**Action code: IMMEDIATELY****Product Safety Warning Letter**

Total Solutions &amp; Power (TSP) accumulators

SL2016-614/PRP  
May 2016**Concerns**

Product safety warning letter concerning accumulators produced by TSP.

Fig. 1: TSP accumulator

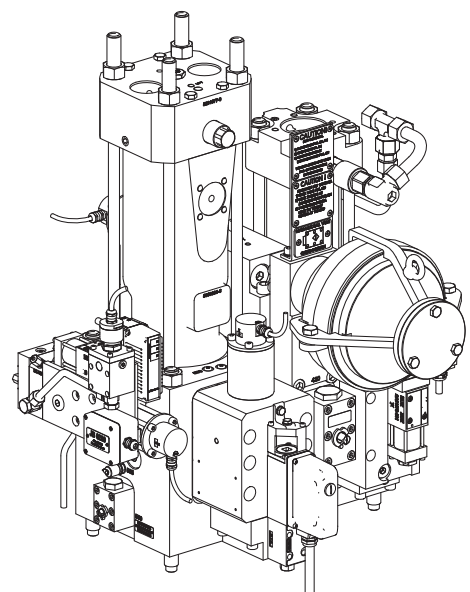
With reference to a few incidents reported, one of the TSP accumulators installed has suffered from breakage, and parts of the accumulator body were ejected into the engine room causing damage to the engine. Accordingly, such breakage poses a serious potential threat to property and persons and may potentially even result in bodily injuries and/or fatal casualties.

A root cause analysis by TSP of one of the failed components has identified the cause to the thread design in the accumulator made by the maker TSP.

The TSP accumulator can be identified as shown in Fig. 1.

TSP has informed us that they have designed a protective guard to be installed on their accumulators as a counter measure. Accordingly, in case your engines have accumulators installed that are made by TSP, you should immediately contact TSP directly for installation of the protective guard.

Until the protective guard has been installed, we encourage you to ensure adherence to the following precautions:

1. As always, ensure that the safety instructions of the Instruction Manual are strictly followed.
2. At the first opportunity, check the nitrogen pressure in the accumulators.
3. The operating personnel should minimise their presence/stay in the vicinity of the running engine and should never be in the vicinity of the affected hazardous area in front of or above the accumulators while the hydraulic system is pressurised, which means during engine running and engine start-up.
